# SERVICE BULLETIN SB - 268

## PRODUCT ADVISORY 960 and 1700 Series Hydraulic Power Pumps

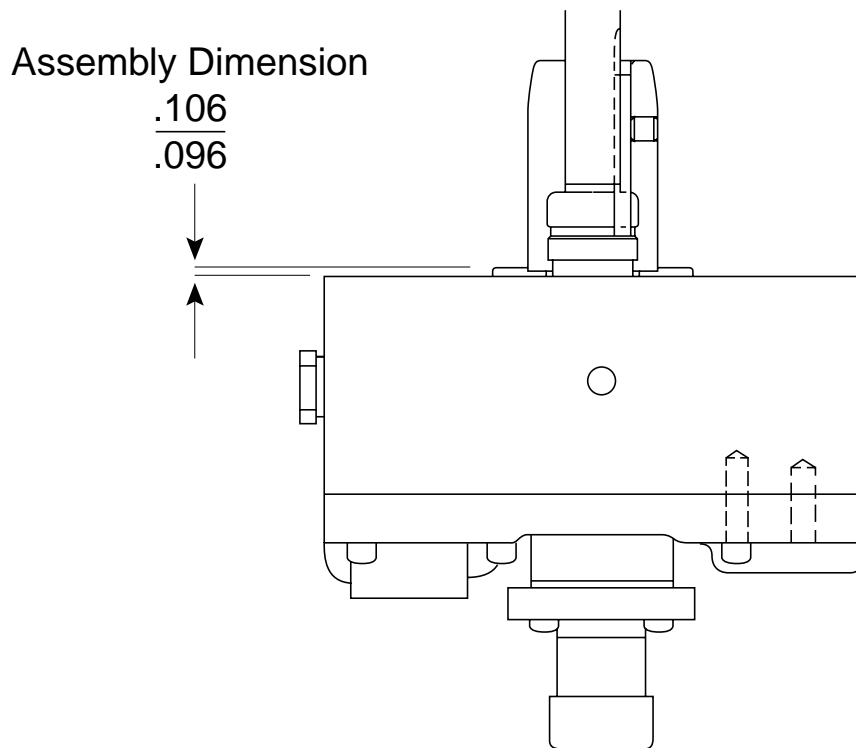
It has come to our attention that the Instruction Manuals for the 960 and 1700 Series Hydraulic Power Pumps do not show the dimension that the top bearing (905 1473.4) should be in relation to the top surface of the pump block.

It should measure between .096 and .106 from the top of the block to the top of the bearing to obtain the proper spacing required for the location of the motor mounting plate.
